SIGAR 14-31 Inspection Report

SALANG HOSPITAL: LACK OF WATER AND POWER SEVERELY LIMITS HOSPITAL SERVICES, AND MAJOR CONSTRUCTION DEFICIENCIES RAISE SAFETY CONCERNS

JANUARY
2014

Figure 1 - Location of Earthquakes in Afghanistan from 1964 through 2004

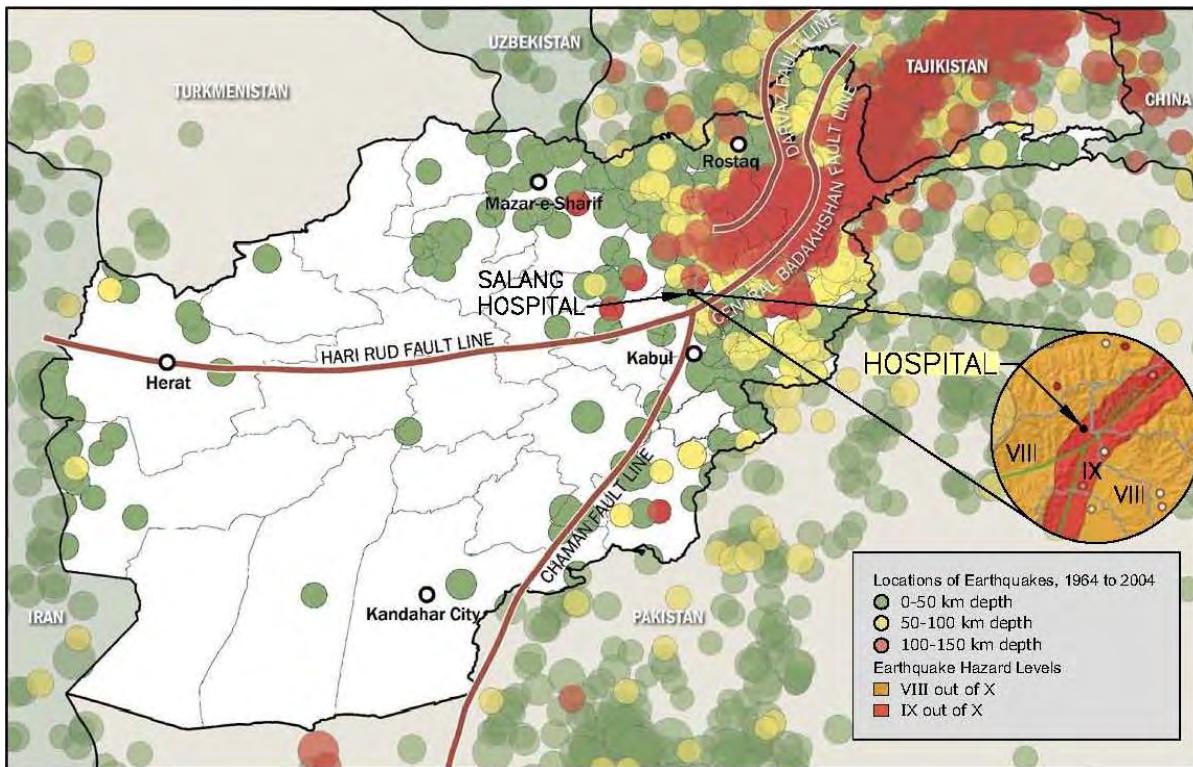
1997 to 2007.⁴ Substandard construction that does not meet industry earthquake standards⁵ exposes the structures involved to increased earthquake vulnerability. Figure 1 shows the proximity of Salang hospital in relationship to the intersection of the Chaman, Hari Rud, and Central Badakhshan fault lines and the location of earthquakes that have occurred in Afghanistan from 1964 through 2004.

According to U.S. Geological Survey data, Salang hospital is located in the second highest seismic intensity zone in Afghanistan. The Chaman and Badakhshan fault lines represent the centerline of a 15 to 25 kilometer wide swath of potential destruction during a seismic event. The U.S. Geological Survey characterizes the seismic activity and potential damage for this zone as Level IX out of X. Level IX activity is described as: "Violent shaking with people forcibly thrown to the ground, monuments and columns fall, and most unreinforced masonry buildings will suffer heavy to very heavy structural damage."

APPENDIX II - COMPARATIVE BUILDING FOOTPRINTS

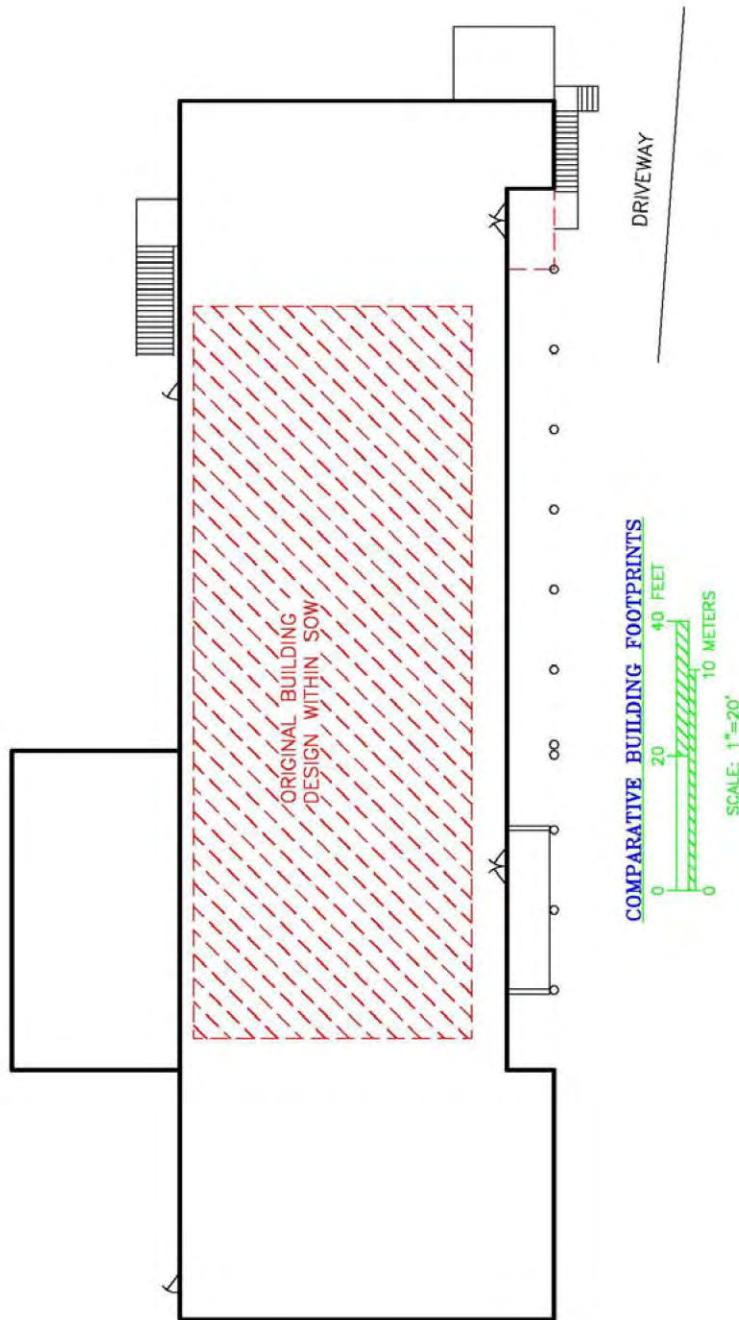
- The original design drawings called for a one-story, 15-room hospital building; a one-story four-stall toilet facility; and a guard shack. However, we found that a two-story building had been built. It was an 18,300-square-foot structure, more than three times larger than the 5,300-square-foot building called for in the original design plans. We could not find any documentation showing that the Bagram Regional Contracting Center contracting officer had modified the contract to approve the two-story building, as was required under the contract.³ According to a Provincial Reconstruction Team record of a meeting with an Afghan Ministry of Public Health official, the Department of State member of the team stated that the Ministry and the provincial government approved the alternate design; however, no documentation exists to confirm that these officials approved the design. The State Department representative also noted that the alternate design was necessary because the hospital's irregularly shaped lot would not accommodate the design called for in the contract documents. However, it is unclear to us why the lot could not accommodate the hospital as originally designed, but could accommodate a facility that had a larger footprint than was called for under the contract. See Appendix II for a comparison of the originally-designed building's footprint and that of the building that was actually constructed.

Note: The outer black lines show the 9,150 square foot footprint of the 18,300 square foot two-story hospital building actually constructed by the contractor. The shaded red box within the black lines shows the relative size of the 5,300 square foot footprint that the Salang hospital would have occupied had it been constructed in accordance with the designs provided for in the contract. It remains a question as to why the lot was inappropriate for the 5,300 square foot building, but suitable for the 18,300 square foot building.
